Access Compliance Report

Public Rights-of-Way

Intersection ID: 29389	Main Street: GOLD_PAN_RD	Cross Street: REEDY_PLANTATION_RD	Location: SW
ADA ID: 502CE9AC3C4C	Ramp Type: PerpDiag	Initial Pass/Fail: Fail	Overall Compliance: No
Severity Score: 21.25			
Codes/Mitigation Info/Possible Solution		Field Measurements/Component Compliance

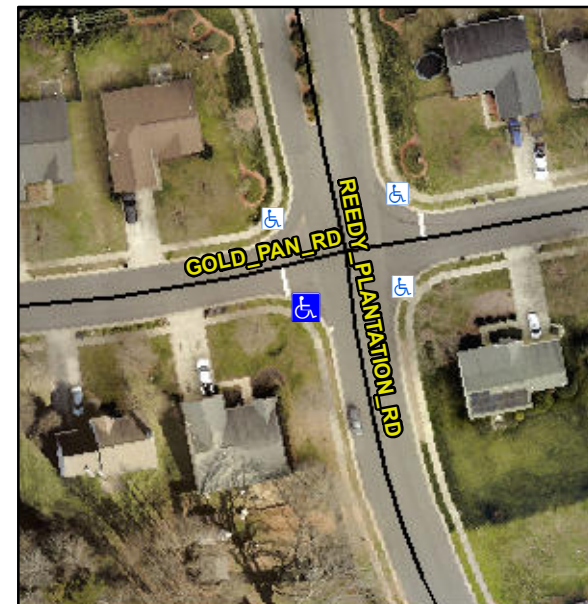
Not Found, R304.5.1, R304.5.3

Compliance	Description	Data	Compliance	Description	Data
N/A	Ramp Length (in)	46.5	Yes	Ramp Slope (%)	5.6
No	Ramp Width (in)	47.5	No	Ramp XSlope (%)	5.2
N/A	Flare Type LT	N/A	N/A	Flare Type RT	N/A
N/A	Flare Slope LT (%)	N/A	N/A	Flare Slope RT (%)	N/A
N/A	Flare Traversable LT?	N/A	N/A	Flare Traversable RT?	N/A
N/A	Landing Length (in)	N/A	N/A	DWS Provided?	N/A
N/A	Landing Width (in)	N/A	N/A	DWS Contrast?	N/A
N/A	Landing Slope (%)	N/A	N/A	DWS Length (in)	N/A
N/A	Landing X Slope (%)	N/A	N/A	DWS Full Width?	N/A
N/A	Landing Curb? (Y/N)	N/A	N/A	DWS Offset (in)	N/A
N/A	Shared Landing?	N/A			
N/A	Gutter Ponding?	N/A	N/A	Gutter Slope (%)	N/A
N/A	Gutter Lip Ht (in)	N/A	N/A	Gutter X Slope (%)	N/A
N/A	Painted X Walk1?	No	N/A	Painted X Walk2?	No
	X Walk 1 Direction	To E		X Walk 2 Direction	To N
N/A	X Walk 1 Width (in)	N/A	N/A	X Walk 2 Width (in)	N/A
	X Walk 1 Slope (%)	3.4		X Walk 2 Slope (%)	0.9
	X Walk 1 X Slope (%)	3.1		X Walk 2 X Slope (%)	2.5

Remove & Replace Curb Ramp With Two New Directional Ramps or Equivalent.
